# **Water Quality Monitoring Items**

RE: Chatham CWMP Alternative Scenario – Sulphur Springs  
Linked Watershed-Embayment Nitrogen Management Model

**To: Robert Duncanson, Director of Health and Environment - Town of Chatham**  
**CC: Fred Jensen, Chair of CAC, William Hinchey, Judith Giorgio, Kevin McDonald, Linda Smulligan, William Redfield, Colleen Furber.**  
**From: Brian Howes, Director Coastal Systems Program SMAST**  
**Sean Kelley, Applied Coastal Research and Engineering**  
**Ed Eichner, Coastal Systems Program, SMAST**  
**RE: Sulphur Springs/Bucks Creek/Cockle Cove: Sewering Scenarios H1330 & K1930**  
**Date: January 15, 2009, Comments February 5, 2009, Revised Final February 20, 2009**

Response to Sulphur Springs/Bucks Creek Comments Provided by Dr. Robert Duncanson, Chatham Director of Health and Environment in a February 5, 2009 letter regarding the MEP Technical Memorandum of January 15, 2009.

Figure 1. Flow path of 1.3 MGD of treated effluent recharged at Chatham WWTF. Discharge to Nantucket Sound would only be if groundwater by-passes the intervening estuaries; this needs supporting hydrogeological evidence (presently unavailable).

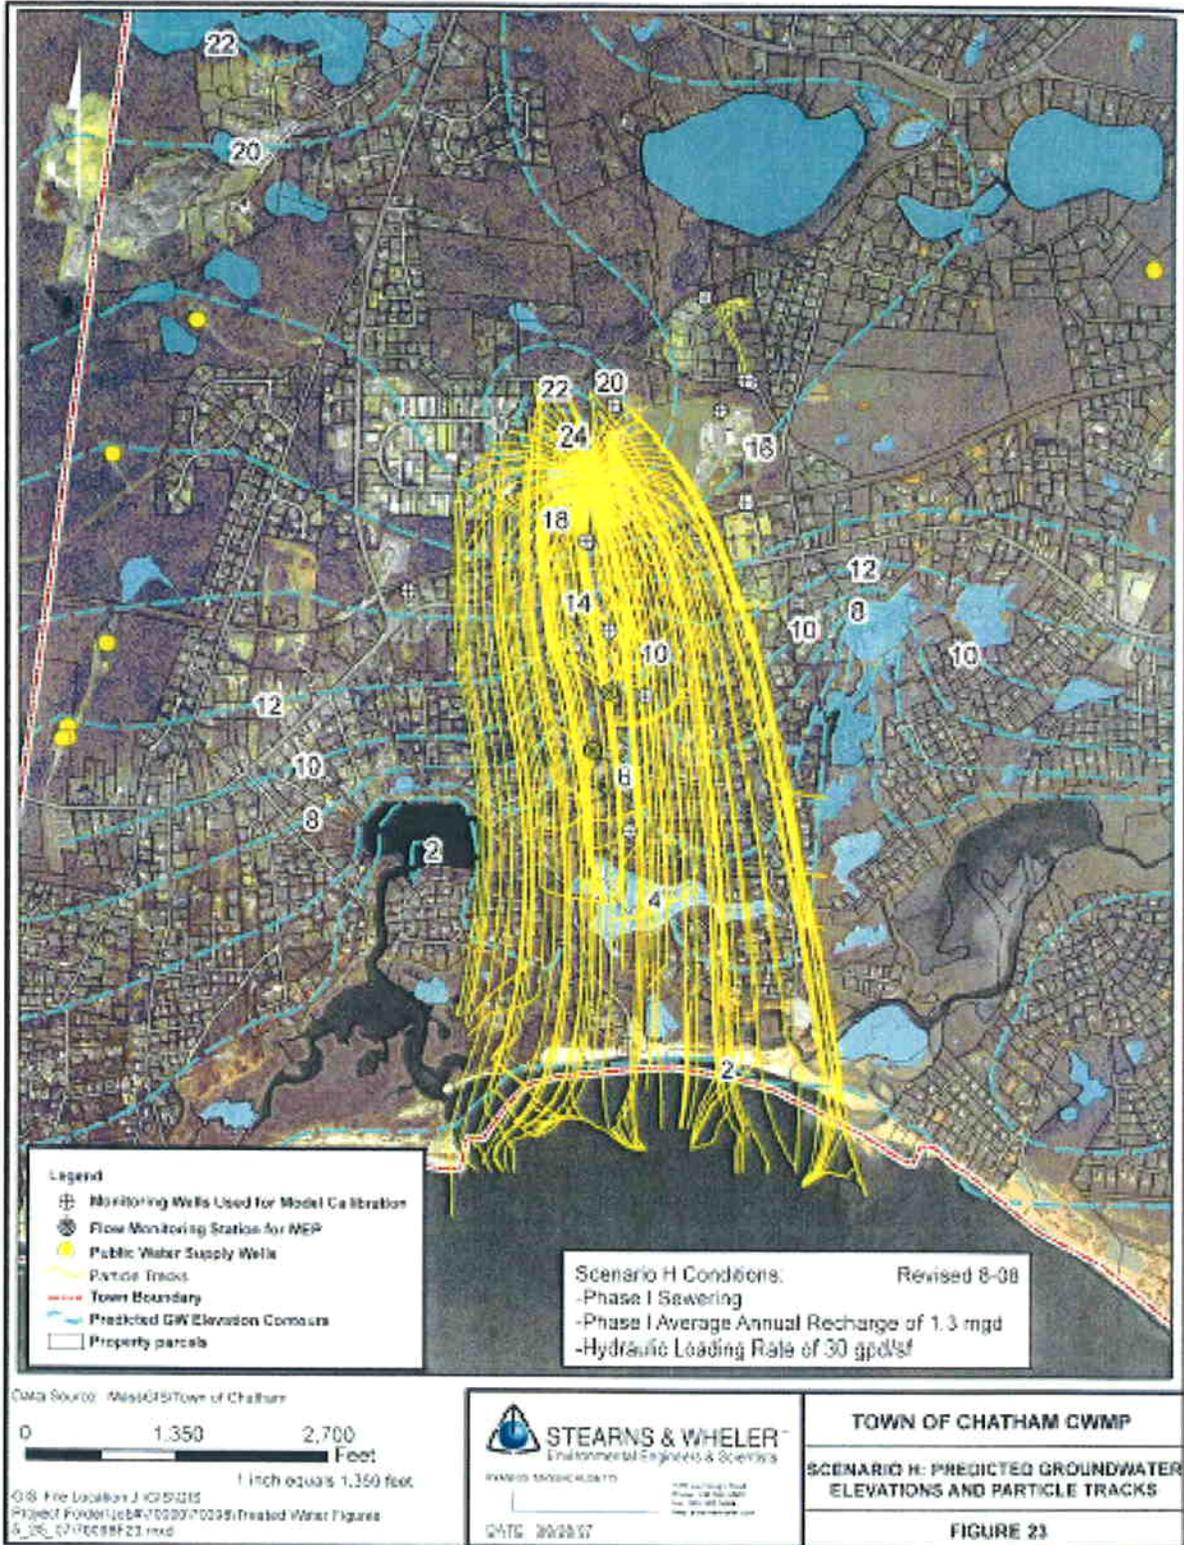
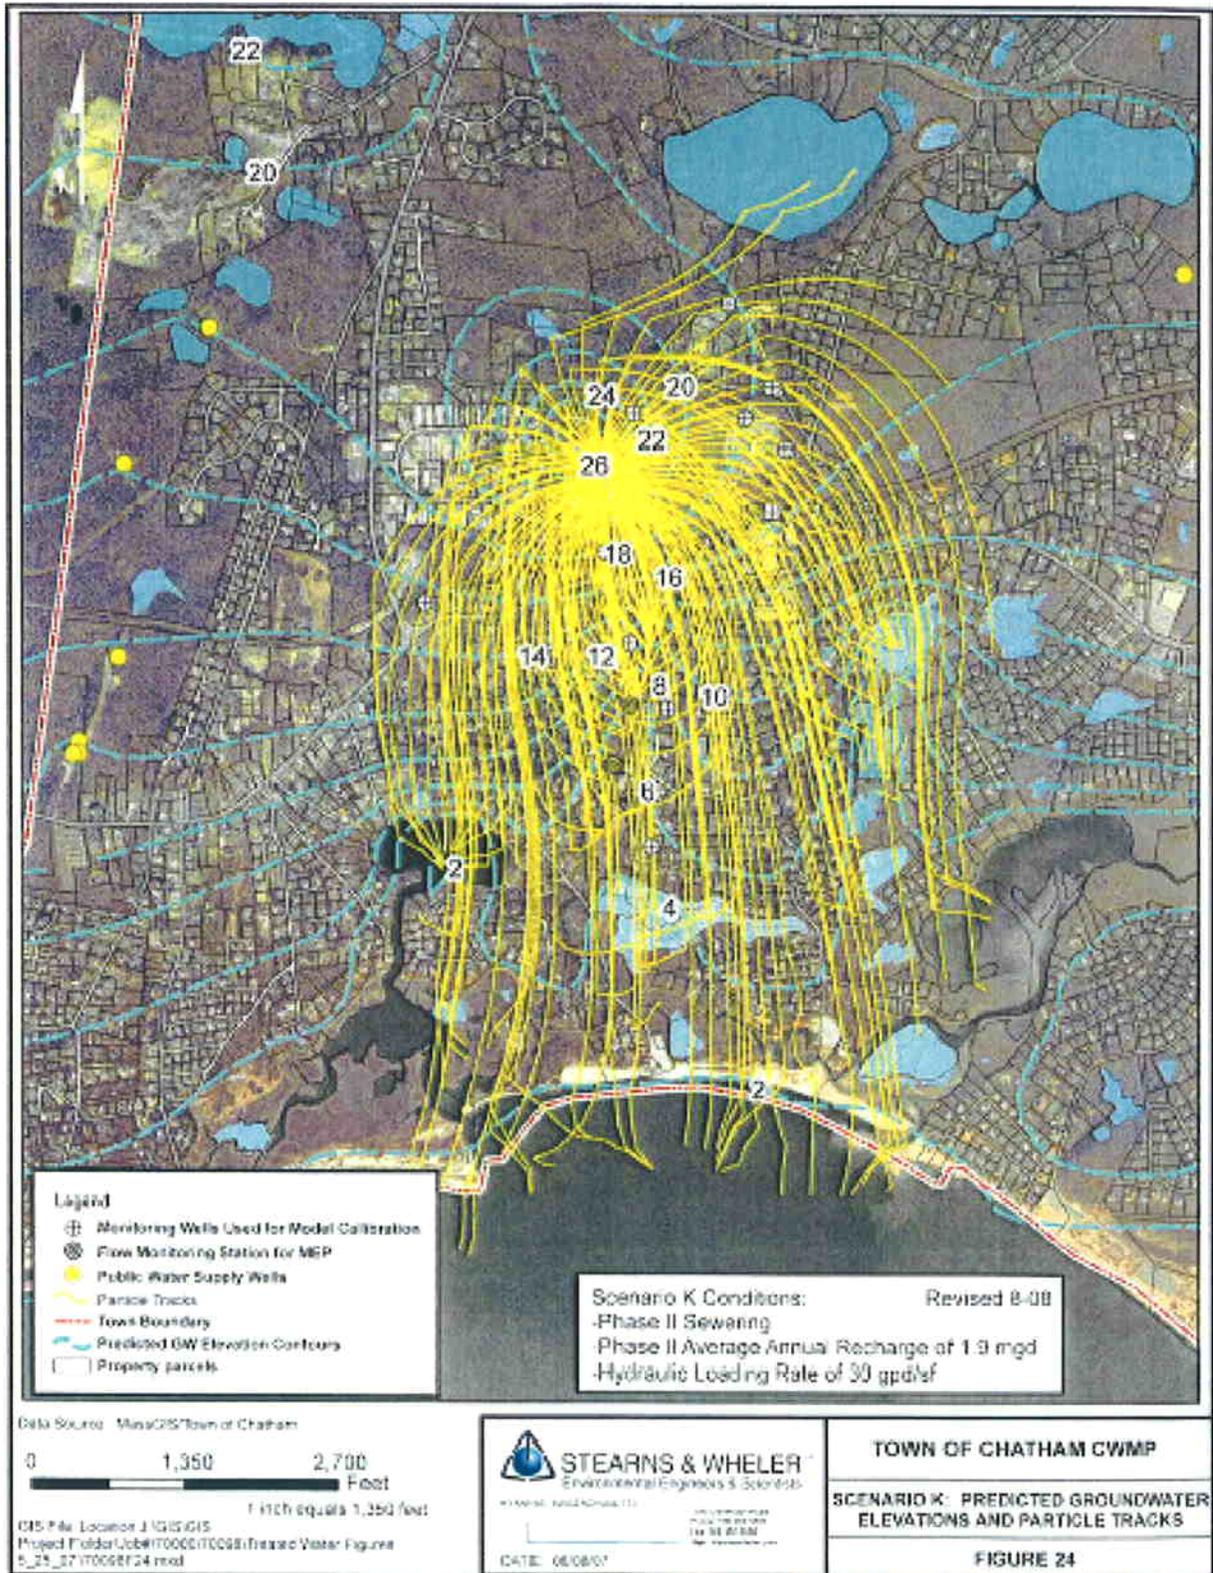
f. *The reference in the caption of Figures 1 and 2 relative to underflow to Nantucket Sound as lacking supporting evidence is opinion. Both the USGS and the more detailed sub-regional groundwater models indicate some amount of underflow to Nantucket Sound.*

- f. The reference in the caption of Figures 1 and 2 relative to underflow to Nantucket Sound as lacking supporting evidence is opinion. Both the USGS and the more detailed sub-regional groundwater models indicate some amount of underflow to Nantucket Sound.

Response: It should be noted that underflow to these estuaries has not been included in the original, approved MEP model configurations or any subsequent scenarios based upon discussions USGS, MassDEP and others. As previously noted, these discussions resulted in agreement that there is no direct evidence of underflow occurring and that assuming all flow is captured by the estuaries would be consistent with conservative principles built into the MEP analyses. The note in the caption confirms that there is a need for validation and hydrogeologic evidence (not modeling) to support underflow. It is not the MEP Team's decision to include or not to include underflow in any specific scenario. It should also be noted that water balance in other systems has not supported discernable underflow, not to say that it can't happen under specific geologic conditions.

Figure 3. Sewer Plan for Taylor's Pond Estuarine System

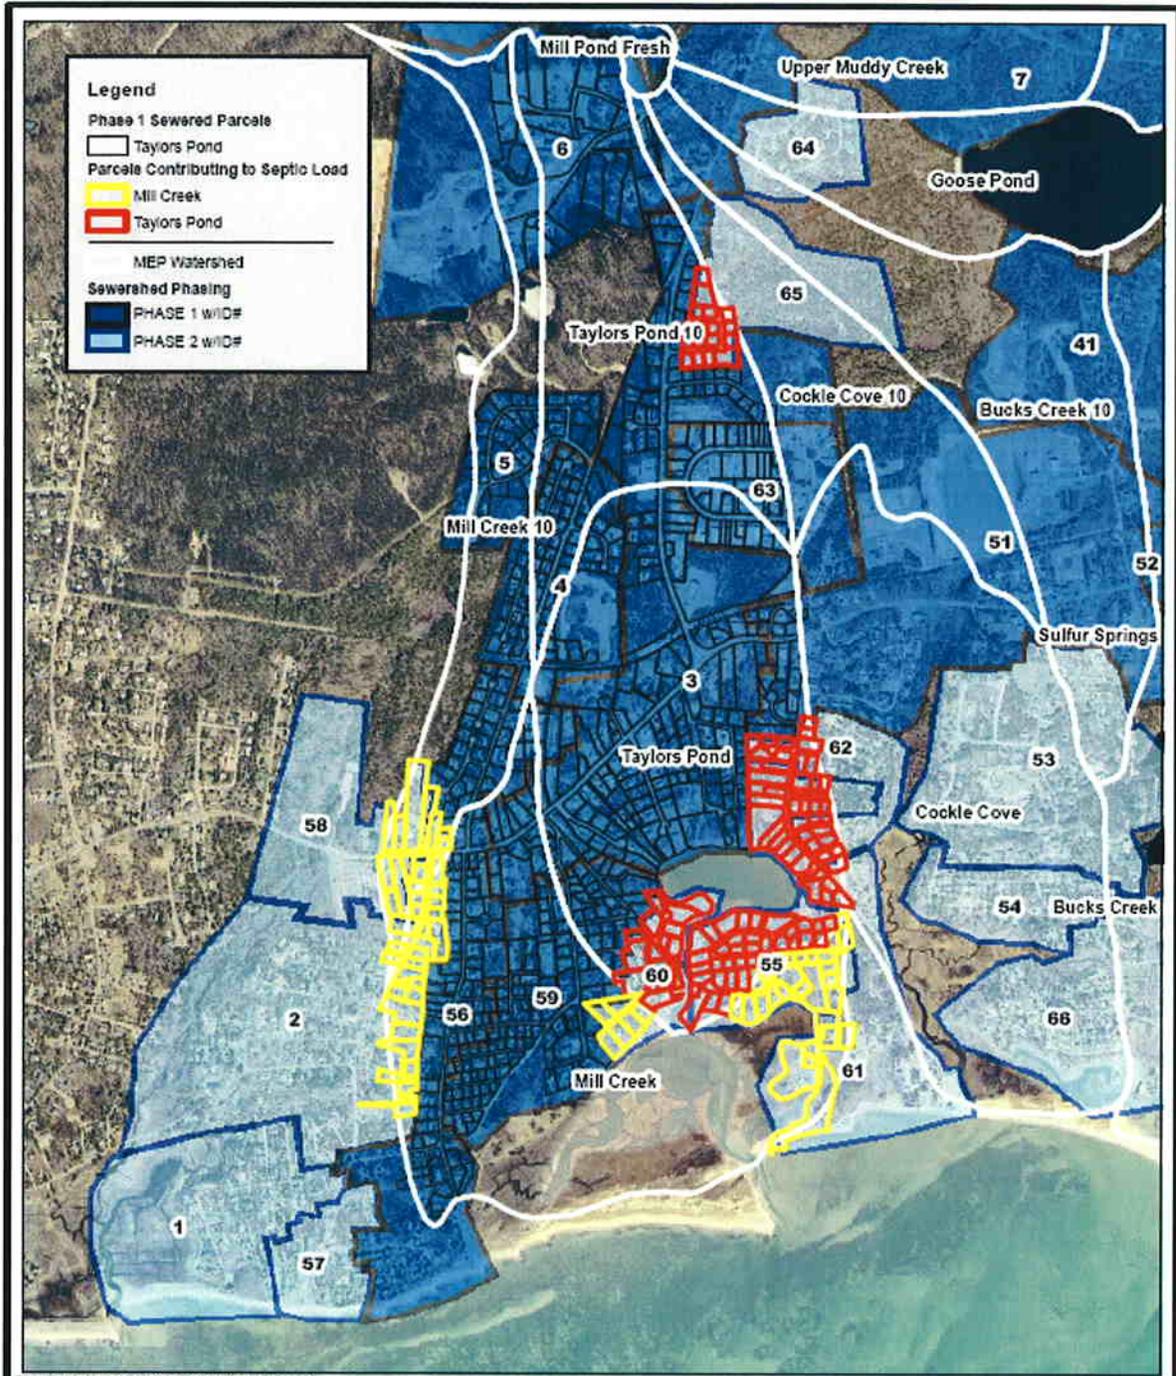
b. 2<sup>nd</sup> para.: *The figure reference for the sewersheds should be figure 3; figures 1 and 2 are the particle tracks.*

- b. 2<sup>nd</sup> para.: The figure reference for the sewersheds should be figure 3; figures 1 and 2 are the particle tracks.
- c. 5<sup>th</sup> para.: The following statement is made: *"It is assumed that watershed N loads passing through the freshwater ponds have been attenuated and included in the septic loads provided (for Taylors Pond System, Mill Pond fresh and for Sulphur Springs System), Mill Pond Fresh and Goose Pond)." This would seem to be the role of the model, to account for attenuation which is built into the model.*

Response: Reference to Figures 1 & 2 added and reference to figures 3 &4 adjusted accordingly.
